**Subject: Beaver Valley Power Station, Unit No. 1  
Docket No. 50-334, License No. DPR-66  
ISI (Inservice Inspection) Program: Relief Requests**

The purpose of this submittal is to request NRC review and approval of proposed relief requests applicable to the Unit No. 1 Second Ten-Year Interval ISI Program. The following relief requests are attached for review:

PRESSURIZER NOZZLE DRAWING  
SHOWING WELD REQUIRED VOLUME  
OBTAINED WITH 45° L ON  
WELD RC-98-1-E-02

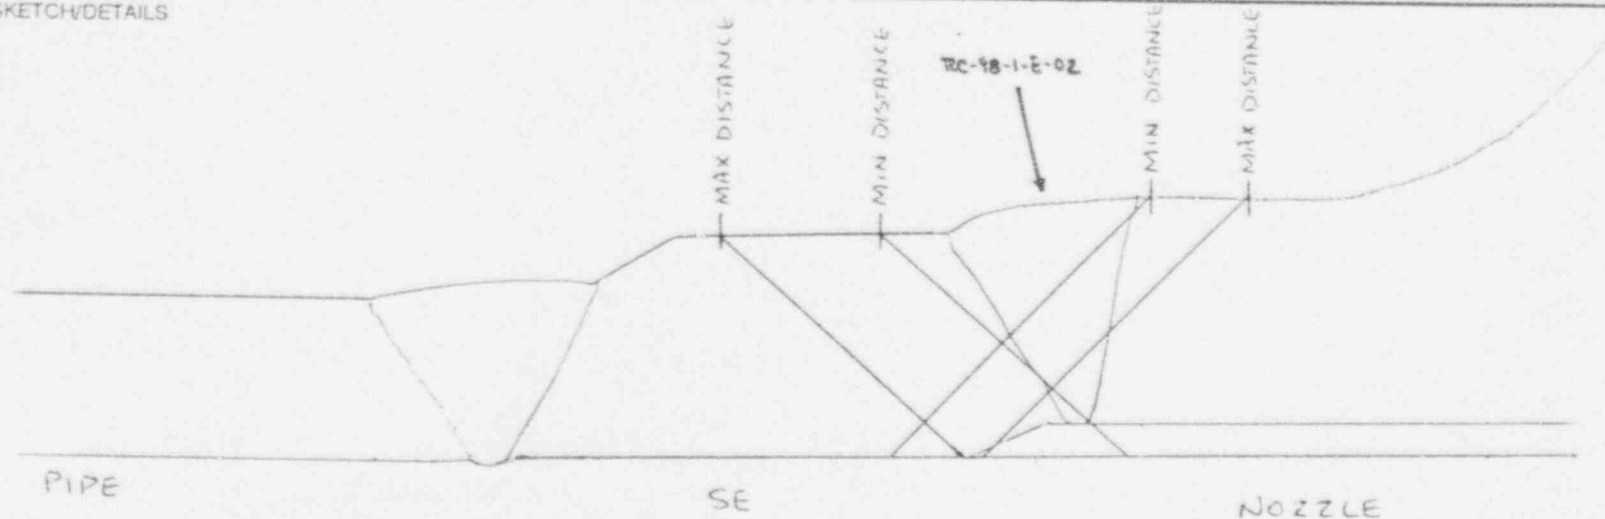
The ultrasonic examination of this weld was limited due to search unit lift off on the nozzle curvature when scanning from the nozzle side. The weld crown and diameter change prevent coverage from the safe-end-side. See attached sketch. This exam was performed using a 45 degree refracted longitudinal scan angle as recommended in NRC Information Notice 90-30.

Approximately 70% of the required volume was covered by this ultrasonic examination. The surface exam was completed without limitation.

Perform the volumetric exam to the maximum extent practicable using the refracted longitudinal scan angle as noted. The surface exam and the normal leakage exams will be performed as scheduled.

ELEVATION RS-P-2A.2B

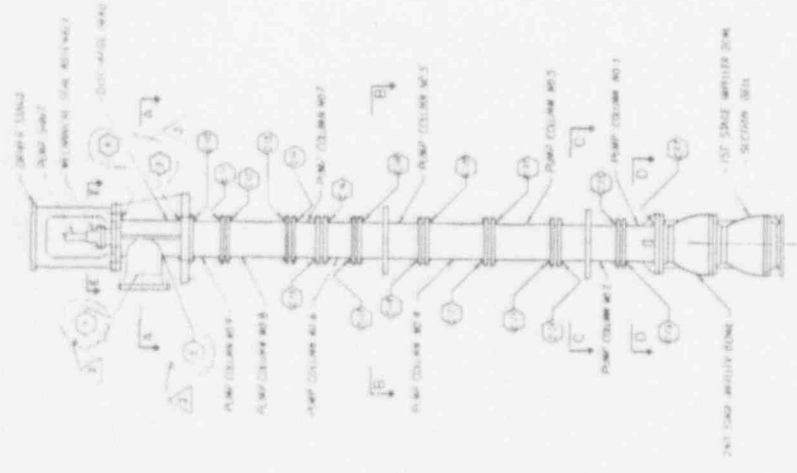
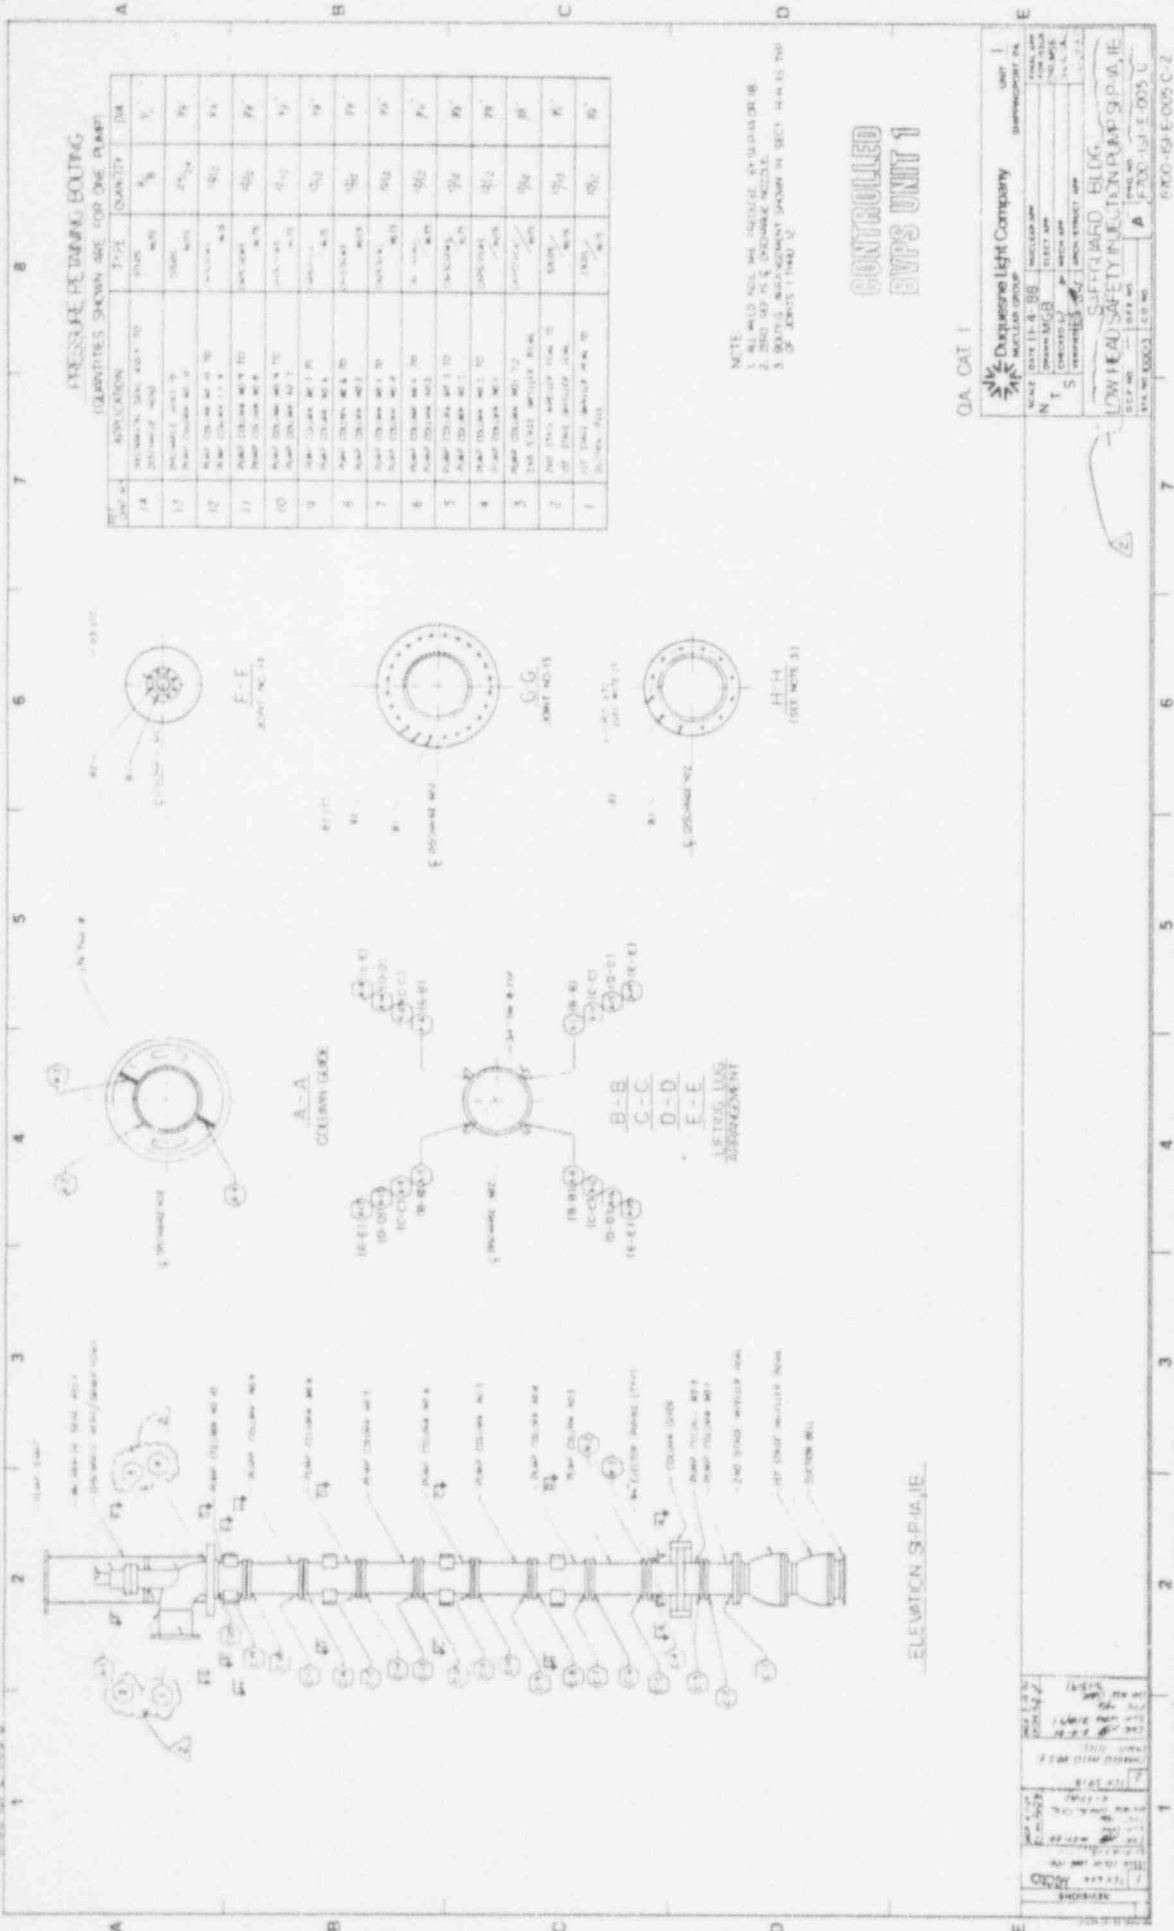
RS-P-2A(2B)-3 and -4	87%	Three (3) welded support plates are located on the welds preventing examination of approximately 13% of the weld. See enclosed photograph.
RS-P-2A(2B)-C-10 thru C-27 RS-P-1A(1B)-C-5 thru C-10	0%	The welds are located below floor level in the pump's sump and are therefore inaccessible. See attached drawings.
SI-P-1A(1B)-C-1 thru C-20	0%	The welds are located below floor level in the pump's sump and are therefore inaccessible. See attached drawings.

For welds limited by the support plates, the surface exam will be performed to the maximum extent possible. For the inaccessible welds located in the pump sumps, the surface exam will be performed only if the pump casing is removed from the sump for maintenance purposes.

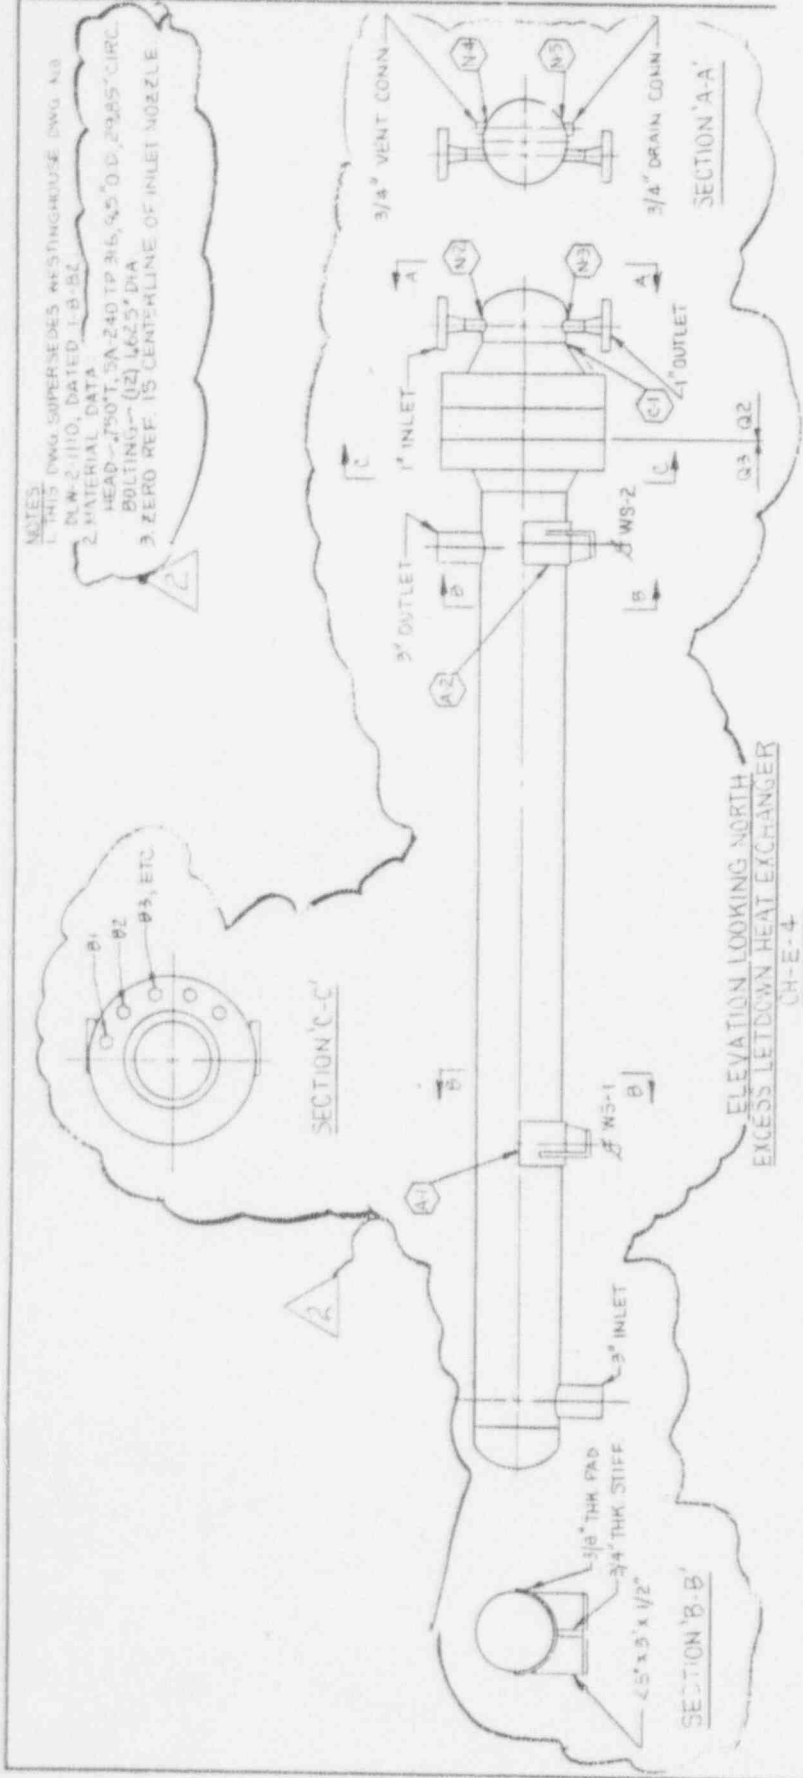
The close proximity of the 1" inlet and outlet nozzles and the .75" vent and drain connections to this weld physically obstruct the path of the search unit limiting the amount of UT coverage to 60% of the required volume. See attached drawing.

None. The volumetric examination will be performed to the maximum extent practicable. The normal leakage exams for this component will continue to be performed as scheduled.

SEAL WATER INJECTION FILTERS (CH-FL-4A & 4B)

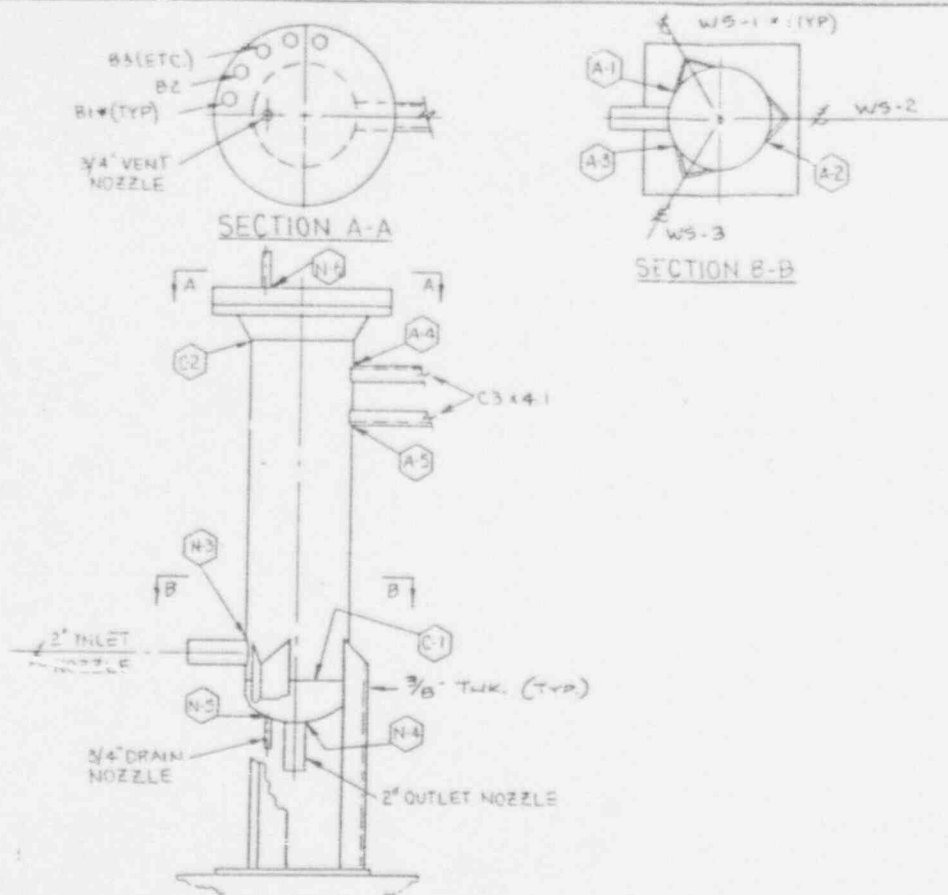
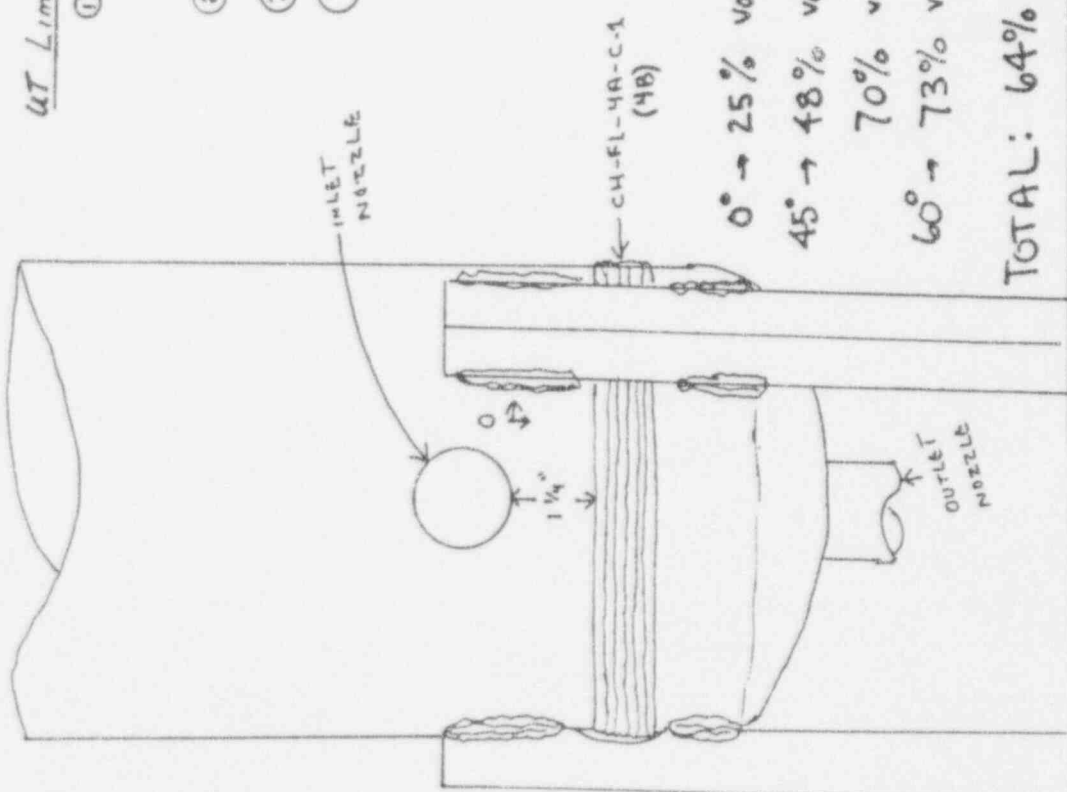
CH-FL-4B-C-1	64%	Three welded angle supports are located over the weld. The inlet nozzle is located within 1.25" of this weld. The as-welded condition of the weld (weld crown) and the curvature of the lower head inhibit the beam path.
CH-FL-4B-C-2	53%	The examination is one-sided due to the flange. The attachment for the filter cover hinge obstructs the search unit movement in that area. The as-welded condition of this weld (weld crown) inhibits the beam path.
CH-FL-4B-N-4	84%	The configuration of the nozzle along with the proximity of a .75" drain line limit scan coverage.

None. The volumetric examination will be performed to the maximum extent practicable. The normal leakage exams for this component and the surface exam on N-4 will continue to be performed as scheduled.

LIMITATIONS TO WELD CH-FL-4A-C-2  
(48)

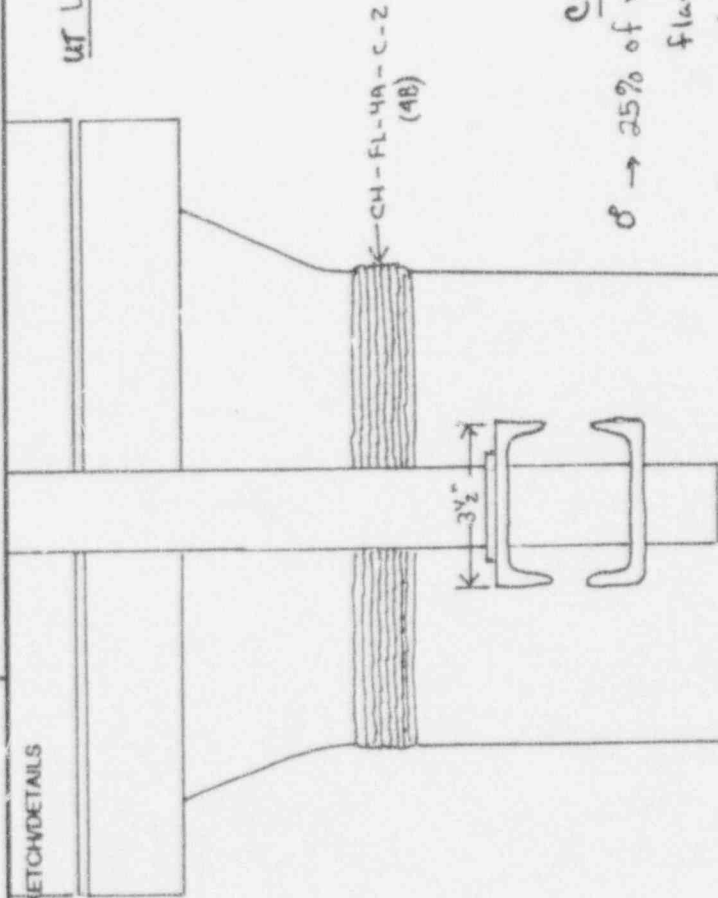
- ① ONE-SIDED EXAM DUE TO FLANGE
- ② ATTACHMENT FOR TOP REMOVAL DEVICE
- ③ AS-WELDED COVER PASS

- 0° → 25% of volume examined due to as welded weld crown, flange, top hinge attachment and name plate
- 45° → 66% of volume examined (1 direction - from shell side - first and second legs)
- 50% of volume examined (direction 3 + 4 - skewing under crown)
- 60° → 50% of volume examined (1 direction - from shell side - first leg)

TOTAL: 53% of required volume covered with angle beams.

CH-FL-4B-N4

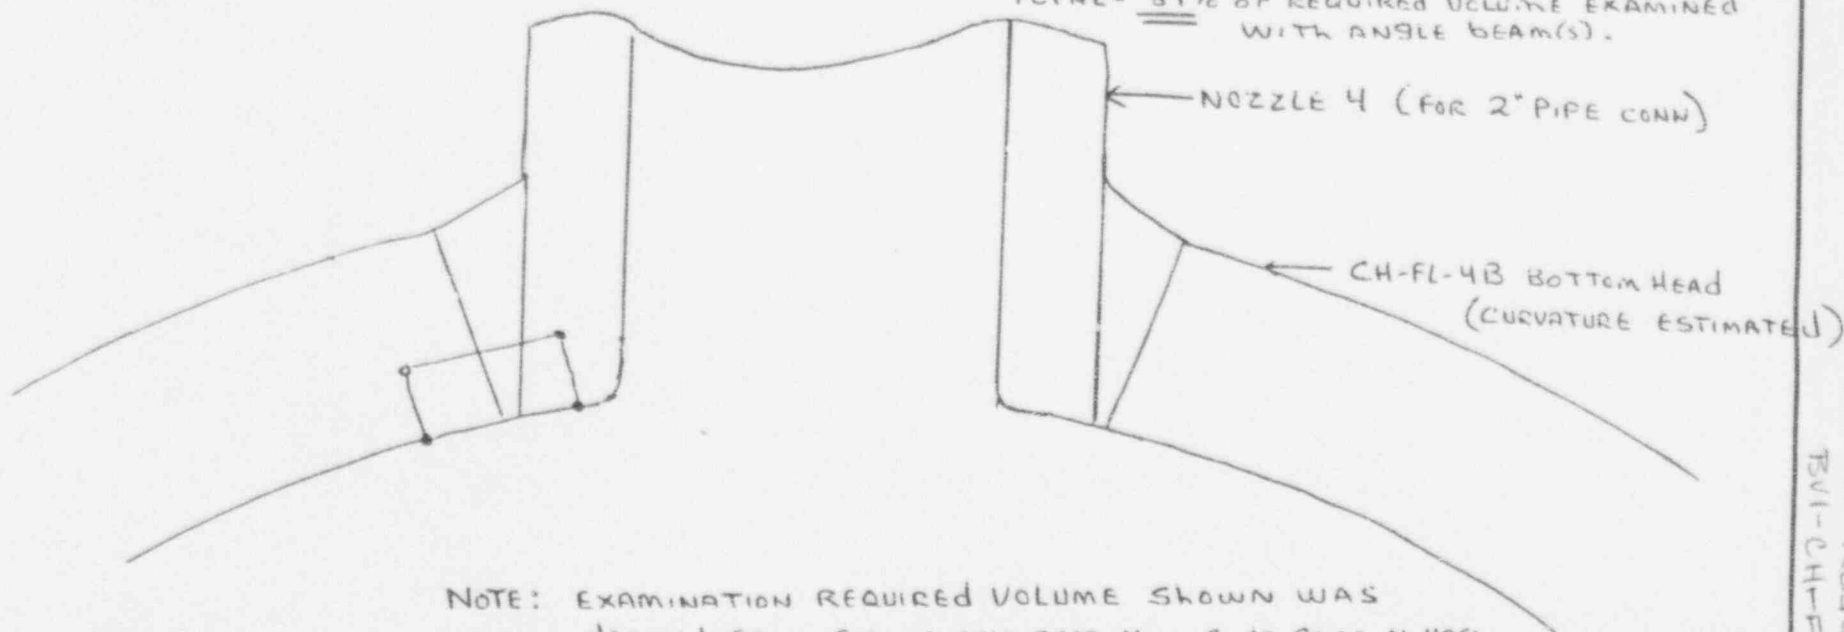
- 0° - 50% OF "REQUIRED VOLUME" EXAMINED DUE TO CONFIGURATION
- 45° - 84% OF REQUIRED VOLUME EXAMINED DUE TO ADJACENT 3/4" NOZZLE (DIRECTIONS 1, 3 + 4)
- 60° - 84% OF REQUIRED VOLUME EXAMINED DUE TO ADJACENT 3/4" NOZZLE.

TOTAL - 84% OF REQUIRED VOLUME EXAMINED WITH ANGLE BEAM(S).

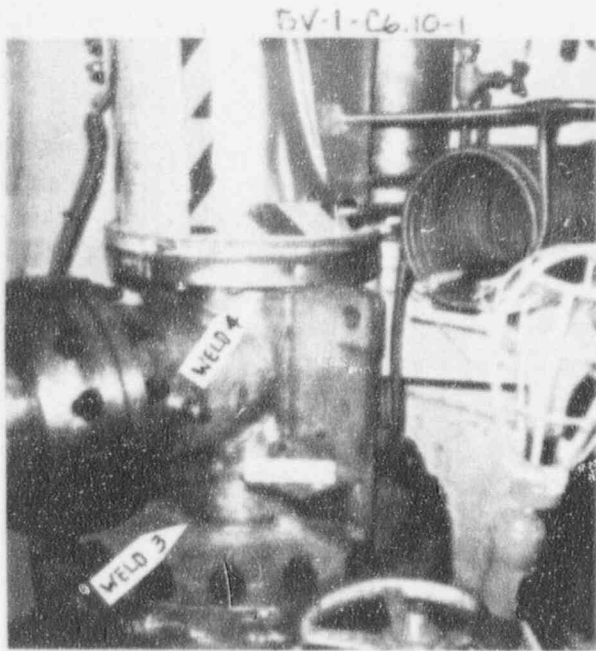
The ultrasonic examination of these welds was limited by the physical interferences of the welded support plates and the inlet and outlet nozzle reinforcing saddles. See attached drawing. Exam coverage is also limited for weld C-1 due to the lower head curvature and weld crown. The 45 deg. axial angle scan was supplemented by a 60 deg. axial angle scan to extend exam volume.

Approximately 84% of the required volume of C-1 and 80% of C-2 were covered by these examinations.

Perform the volumetric examination to the maximum extent practicable, using the supplemental scan as noted above.
